Access Compliance Report

Public Rights-of-Way

(Pedestrian Signals)

Intersection ID: N/A	Main Street:	Cross Street: N/A	Location: N/A
ADA ID: 13BF346C6E25	Signal Type: Two Push Buttons-APS	Overall Compliance: No	Severity Score: BTN 1: N/A BTN 2: N/A No BTN: N/A
Codes/Mitigation Info/Possible Solution		Field Measurements/Component Compliance

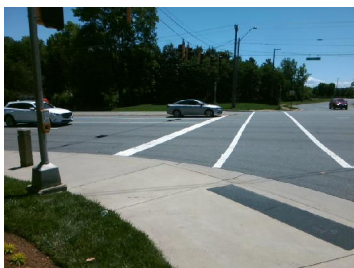
Surveyor Notes: TX HEIGHT 3/8

PROW/ADA: R410.6, TMUTCD 4e.08, R404.2, R406.2,

Possible Solutions: Replace Signal Push Button With APS Button on New Post. Remove & Replace Sign.
